Alaska Highway Gas Pipeline

Technical Hearings
(June 7-12, 1982)

Final Report of
the Environmental
Assessment Panel

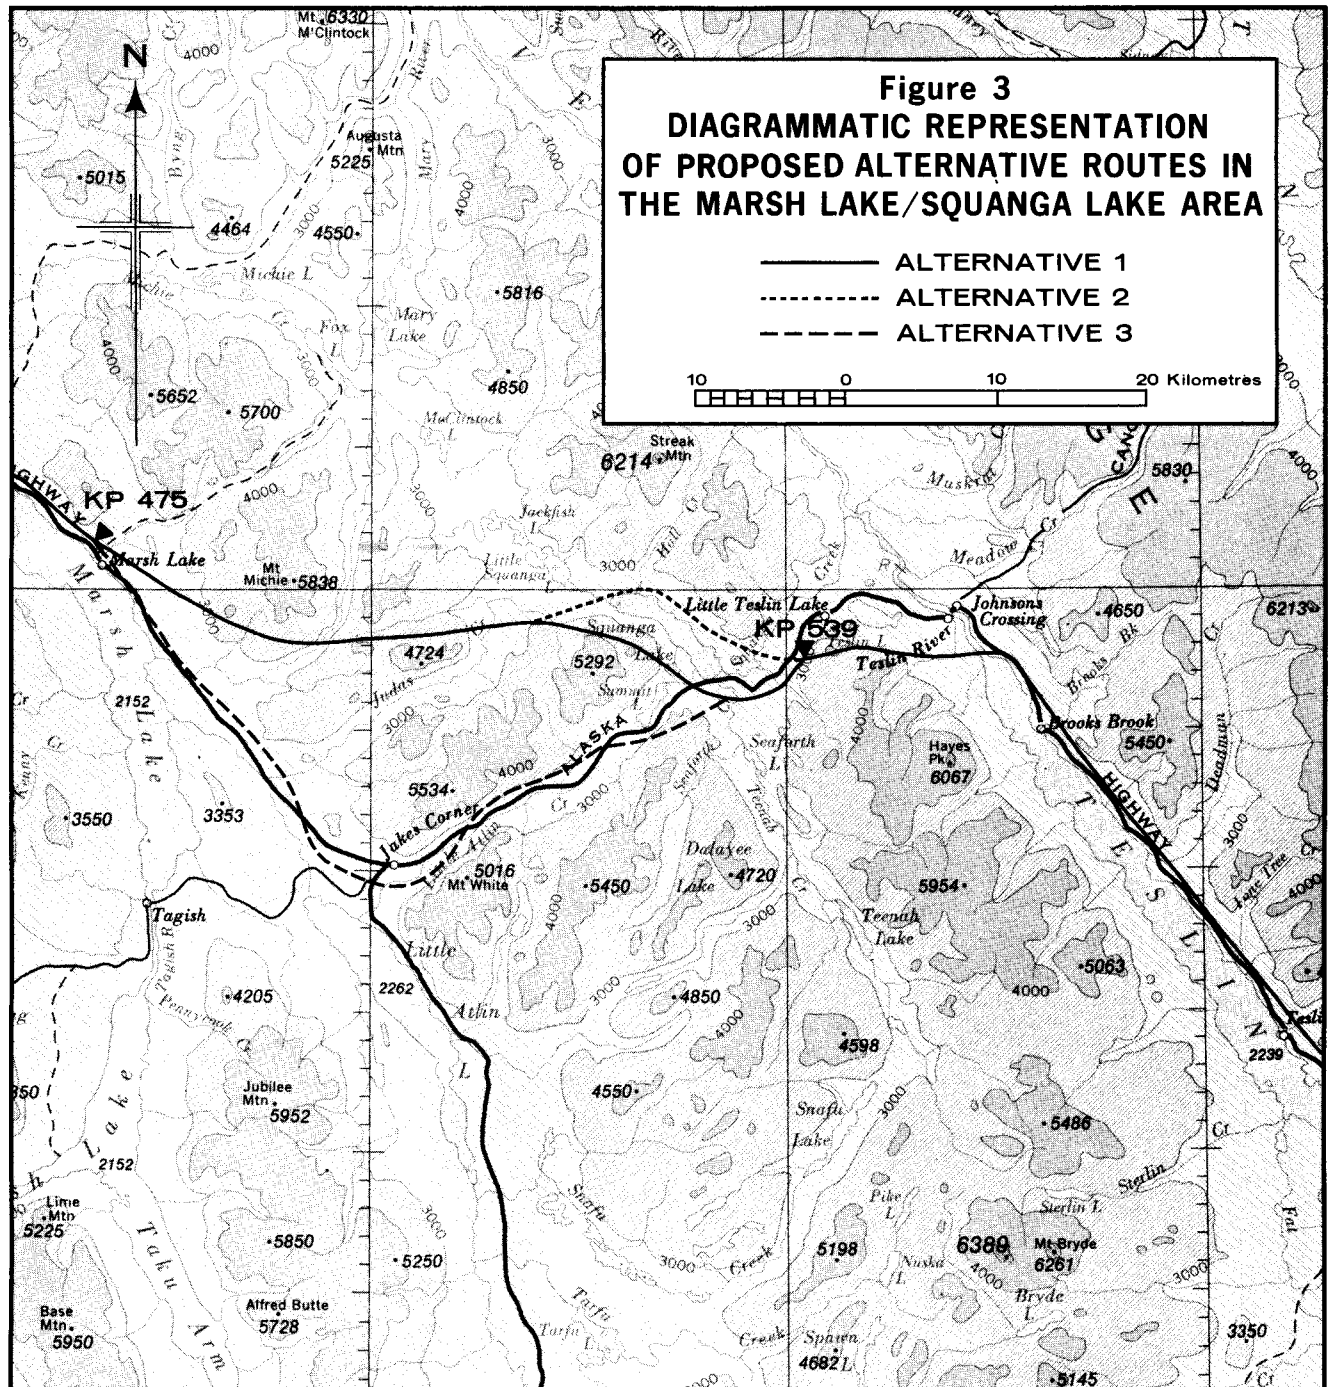
The Panel required "an evaluation of environmental impacts and proposed mitigation measures for the area extending from the east end of the Kluane Lake underwater crossing to where the alignment rejoins the Alaska Highway (approx. KP 225 to 250). (See Figure 2.)

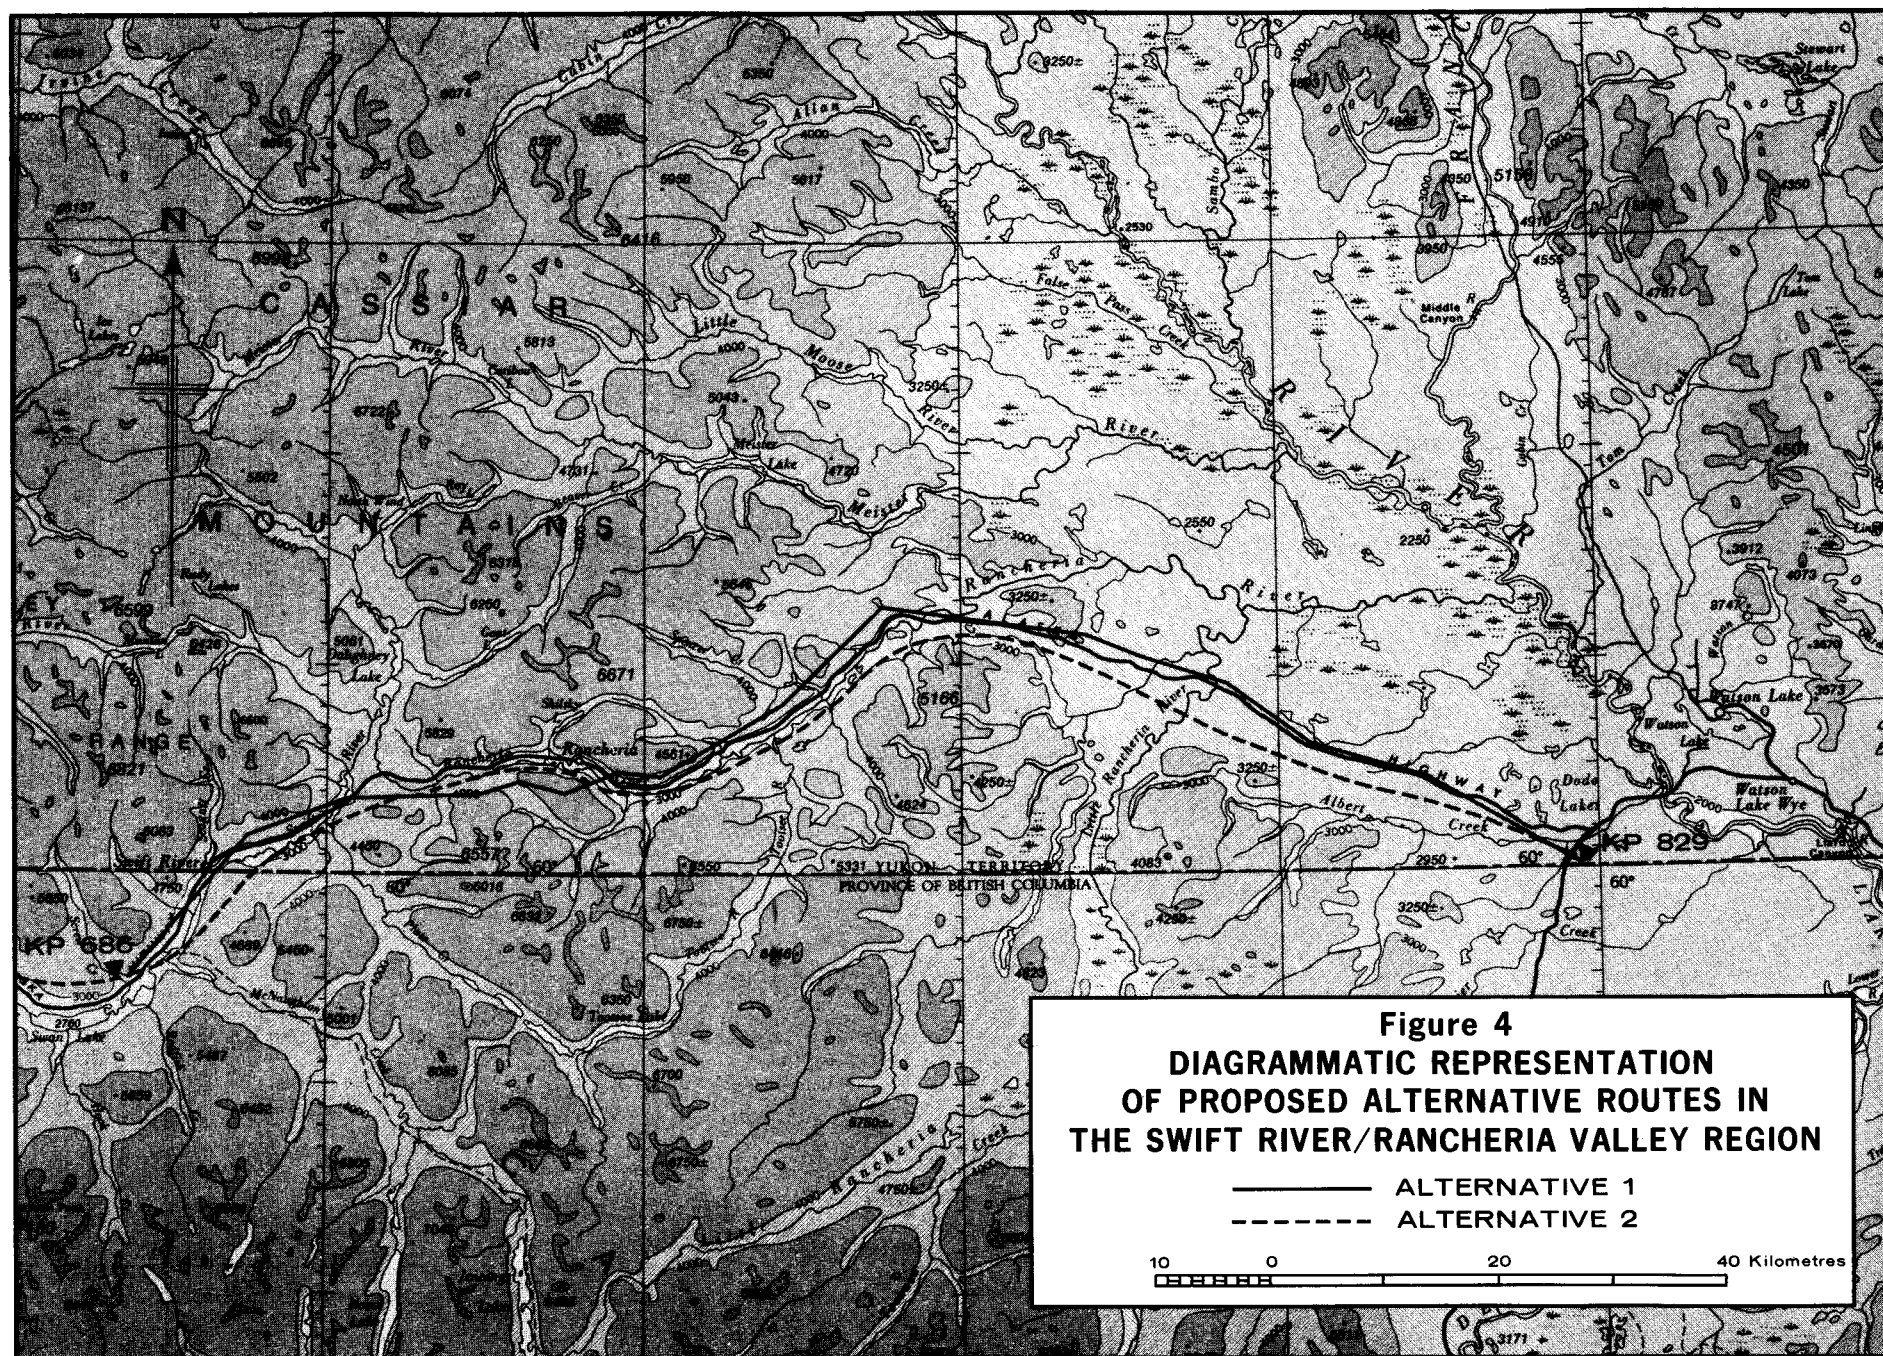
the south side of the Rancheria River and Alaska Highway to the point where the line enters British Columbia near Watson Lake (See Figure 4).

Recommendation 22: Further information should be obtained on winter range use by the Rancheria caribou population in order to develop mitigation measures to protect the population.
